December 6, 2010
U7-C-STP-NRC-100251

South Texas Project
Units 3 and 4
Docket No. PROJ0772
Response to Request for Additional Information

Reference: Request for Additional Information Re: South Texas Project
Nuclear Operating Company Topical Report (TR) WCAP-17079P
Revision 0, "Supplement 3 to BISON Topical Report RPA 90-90-P-A
SAFIR Control System Simulator"

Figure 16a-1 Results from the Turbine Trip Analysis

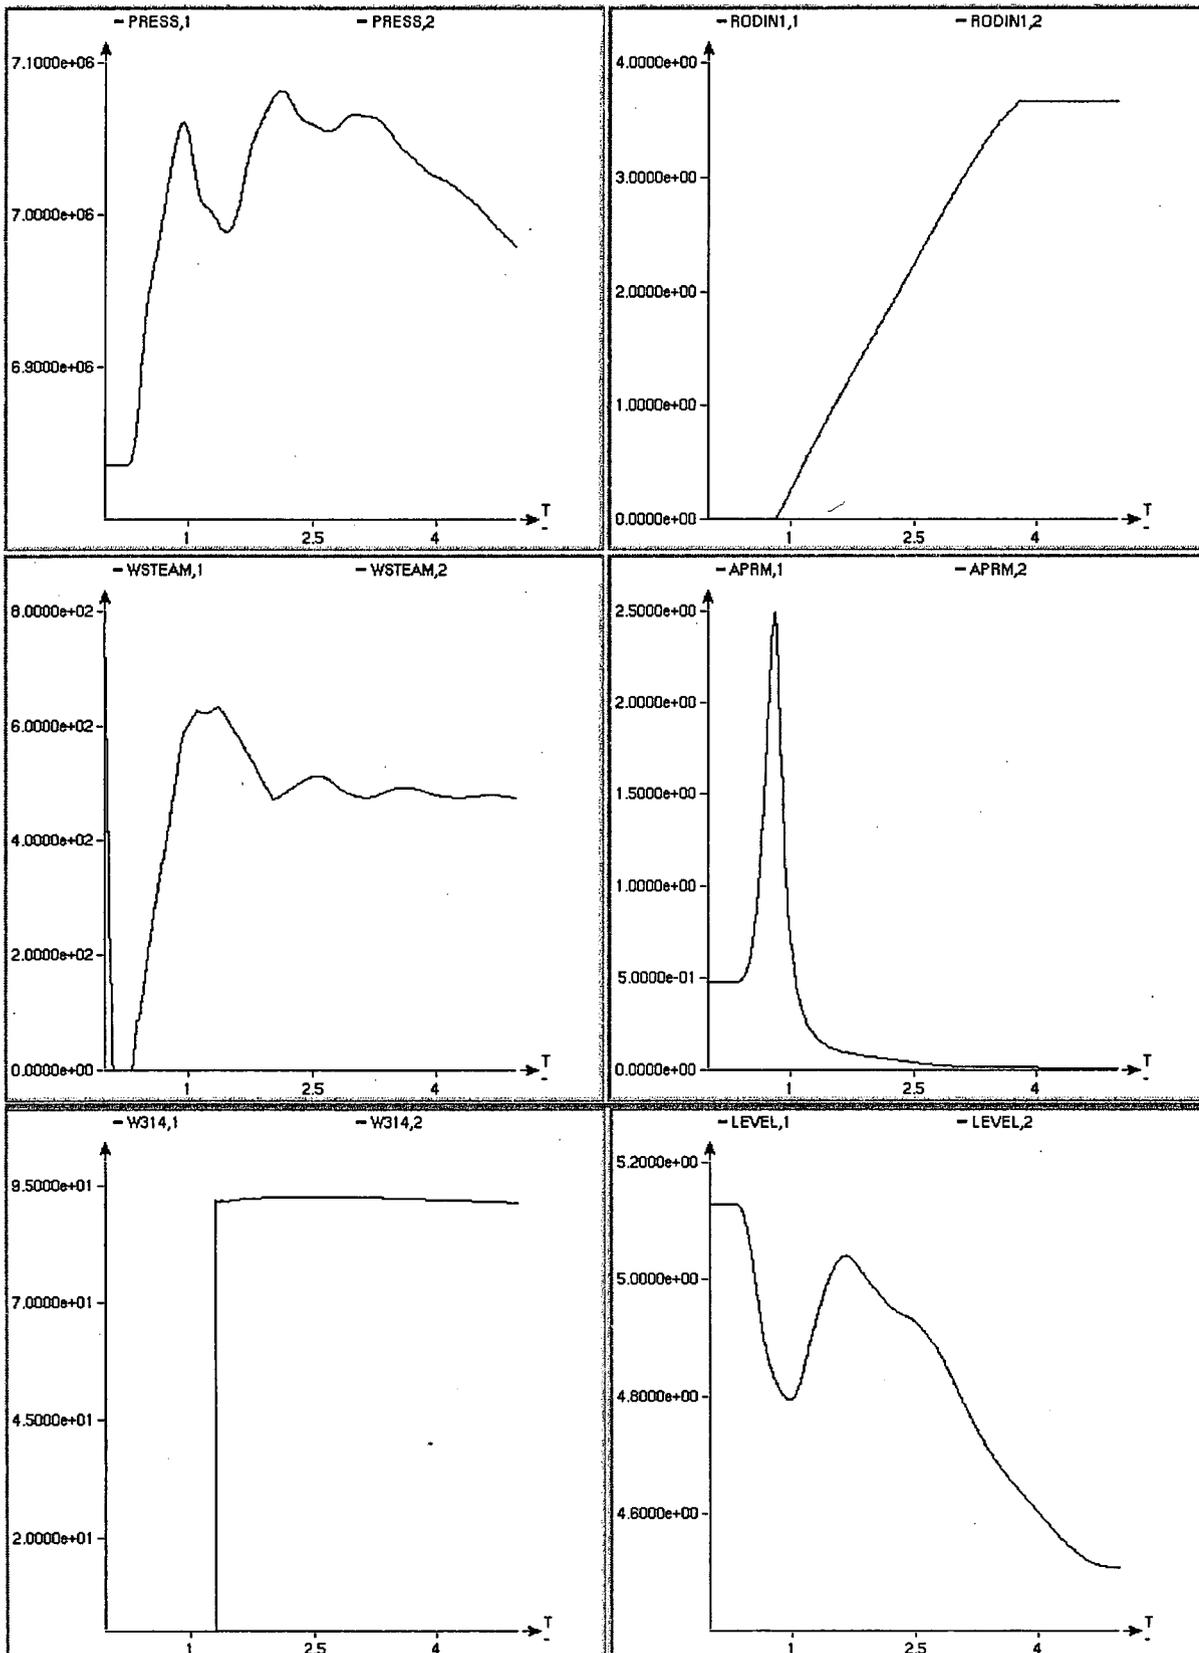
- a) Provide an assessment of changes in performance of the evaluation model resulting from coupling of BISON and SAFIR by providing a detailed comparison of at least two ABWR transients. This would involve comparing the results of BISON-SAFIR evaluation model with and without using SAFIR to model control systems. These assessment calculations should consist of ABWR transient scenarios that fall within the defined applicability of the previous and revised evaluation models. Furthermore, the transients chosen should demonstrate the acceptable modeling of safety and non-safety systems important to the progression of the transients.

Figure 16a-1 below shows a comparison of BISON and BISON with the inclusion of SAFIR for the turbine trip transient. The first case is performed with BISON alone, using the tabular look-up for control systems from RPA 90-90-P-A. The second case includes the SAFIR control system modeling tool, which detects the RPS trip in the APRM system and initiates the reactor SCRAM. A simplified SAFIR RPS model was introduced to the BISON analysis to determine the impact, if any, the addition of SAFIR has on BISON. Figure 16a-1 shows the response of the steam dome pressure (PRESS), length of control rod insertion (RODIN), steam flow (WSTEAM), average power range monitor (APRM), safety valve steam flow (W314) and water level (LEVEL) during the transient.

As can be seen from Figure 16a-1, the output from BISON produces identical results, confirming that the introduction of SAFIR to model the control systems does not change the functionality or results from BISON for this transient.

Figure 24a-1

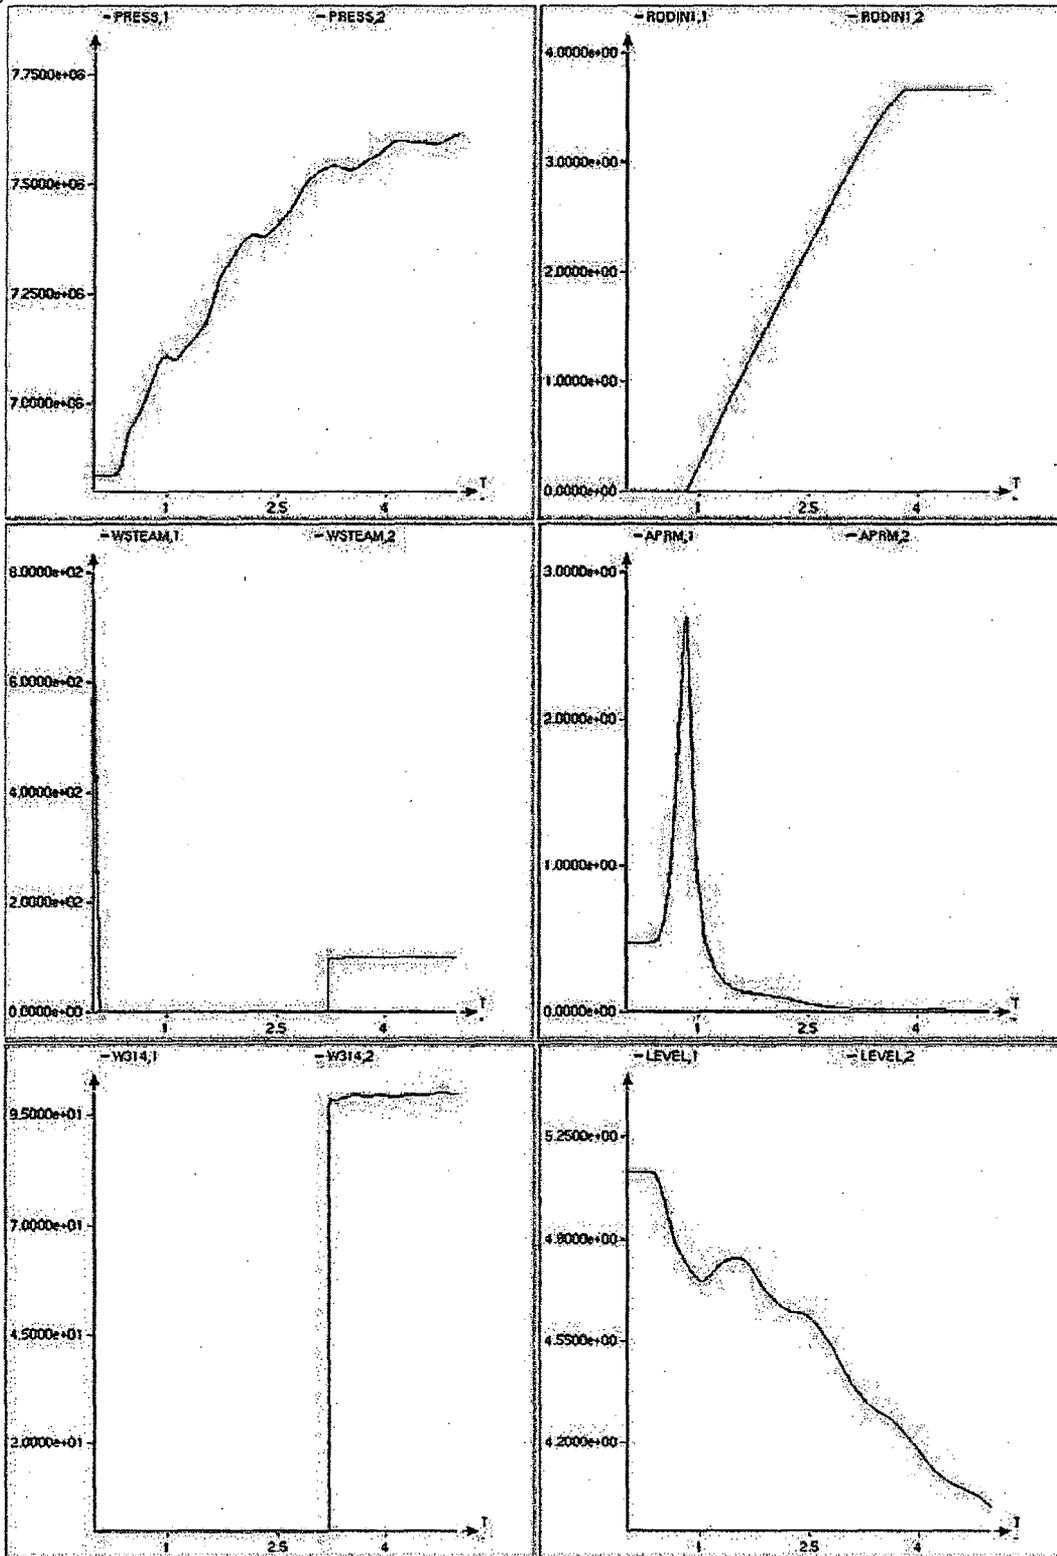
- a) Provide documentation of the basis for removal of the limitation regarding the steam line or PARA steam line model.
- b) Provide details of the ABWR steam line model as implemented in BISON-SAFIR and demonstrate by means of the results of an appropriate calculation that the model accurately reproduces the real system's behavior or bounds it conservatively.

The removal of the PARA steam line model SER limitation is not a subject of the WCAP-17079-P. After examining the PARA steam line model it was determined to maintain this restriction. Hence, when SAFIR is used in conjunction with a PARA steam line model, valve performance will be modeled in compliance with the PARA SER limitation for US NRC approved fast transient or ATWS methodology. Figure 24a-1 shows the response of the steam dome pressure (PRESS), length of control rod insertion (RODIN), steam flow (WSTEAM), and average power range monitor (APRM) during the transient. These two cases can be seen in Figure 24a-1, the addition of SAFIR to the PARA model does not alter the ability to comply with the SER limitation from CENPD-292-P-A. Conservative modeling is still maintained with the implementation of SAFIR.

As demonstrated in part a) of this response, SAFIR will continue to conservatively bound the control systems models in the PARA steam line model.
